To: T10 Technical Committee
From: Rob Elliott, HP (elliott@hp.com)
Date: 12 March 2005
Subject: 05-107r1 SAS-1.1 SAM-4 Overlapped tag handling

Overview

Figure 1 — ST_T (transport layer for SSP target ports) state machines

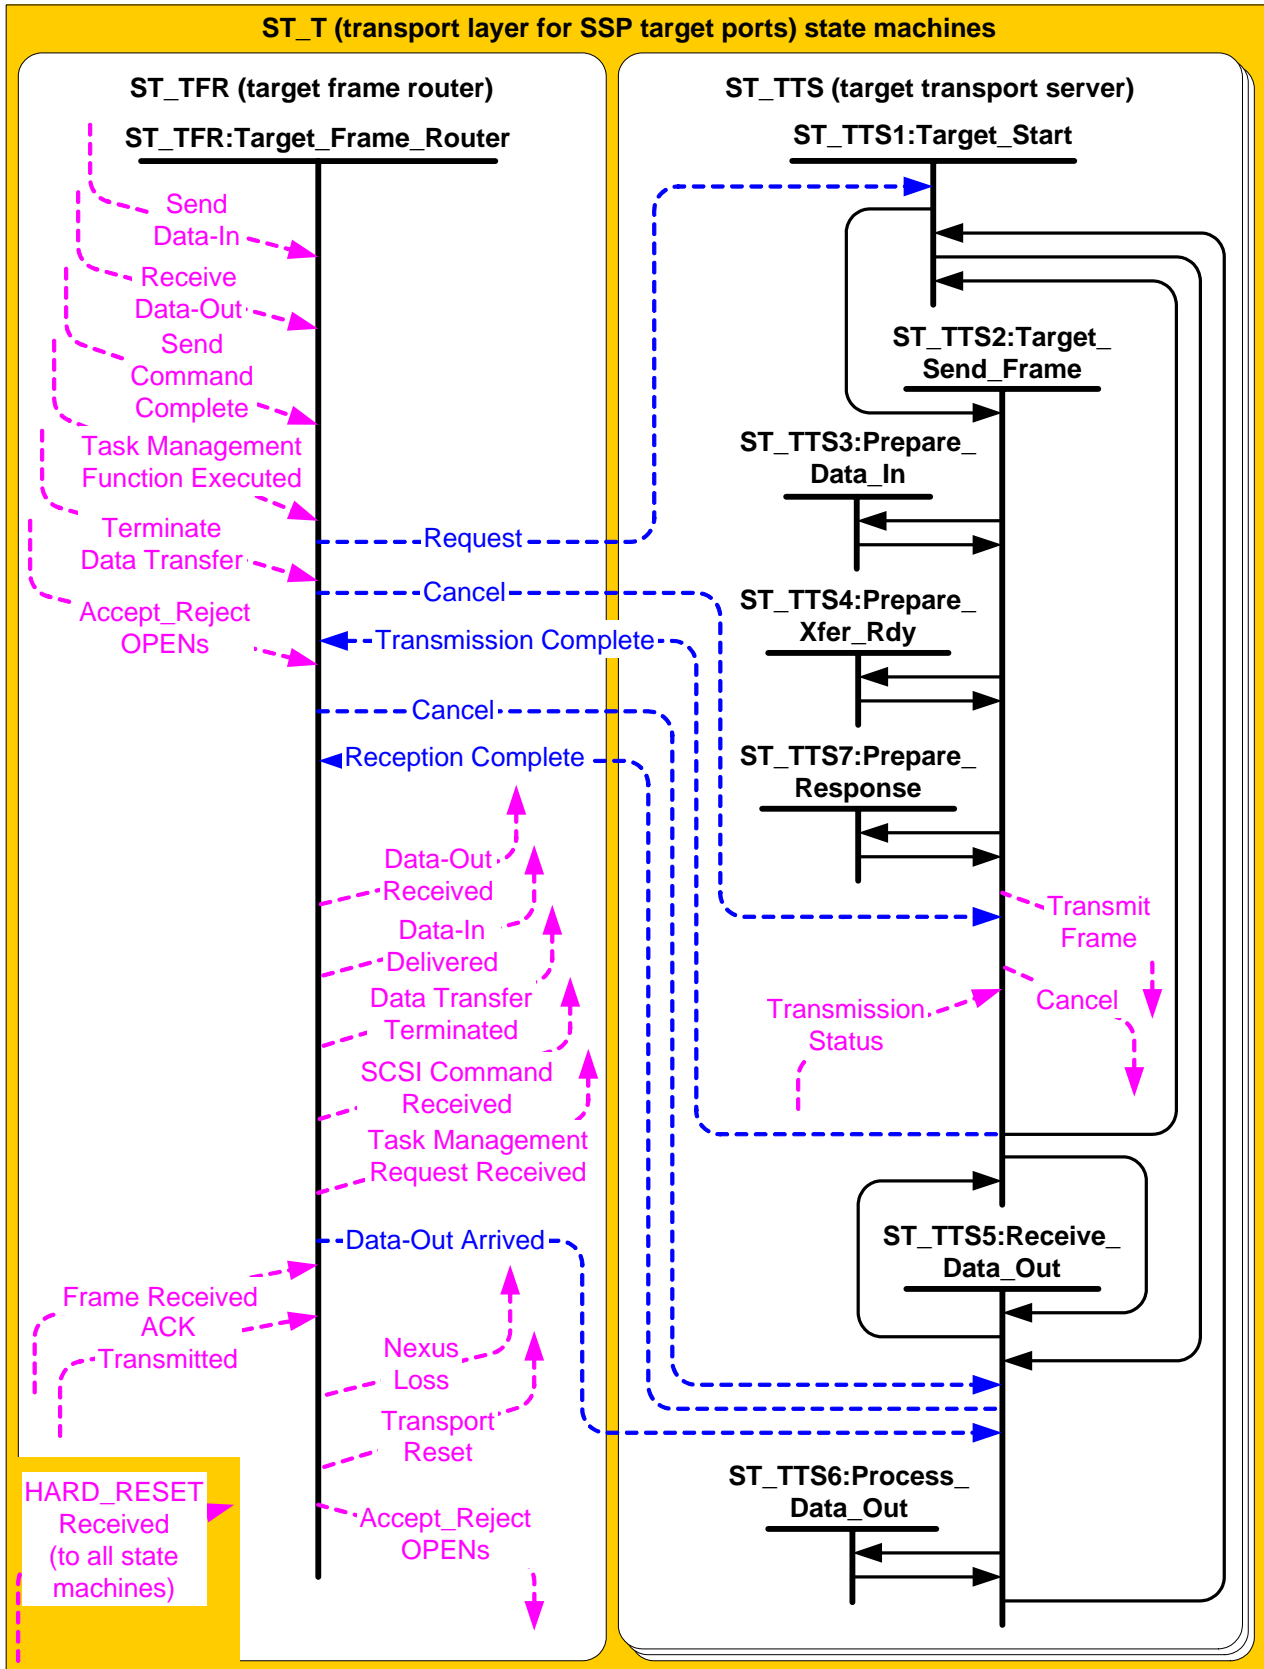
2. The ST_T state machine lacks a means to get the task management function result from the application layer into the RESPONSE frame - the current text refers to status and sense data, which only apply to commands not TMFs.

Editor's Note 1: ST_TFR simply sends up SCSI Command Received or Task Management Request Received and lets the application determine if there is a tag conflict and return a **RESPONSE** frame indicating the problem (and do whatever else is required). Send (Request Transport Response) will not imply a **RESPONSE** frame carrying **RESPONSE_DATA** type only requested by the transport layer; it can also be requested by the application layer. This helps the overlap case and also is needed for normal TMF completion, which was not supported.

If this state machine receives a Task Management Function Executed transport protocol service response from the SCSI application layer, then this state machine shall send a Request (Send ~~Application~~Transport Response) message [to the ST_TTS state machine specified by the tag with the argument described in table 5 and with the following arguments](#) ~~to the ST_TTS1:Target_Start state in an ST_TTS state machine that does not have an active task:~~

- a) connection rate;
- b) initiator connection tag;
- c) destination SAS address ([i.e., the SAS address to which the RESPONSE frame is to be transmitted](#)); [and](#)
- d) tag;
- ~~e) the status; and~~
- ~~f) the sense data..~~
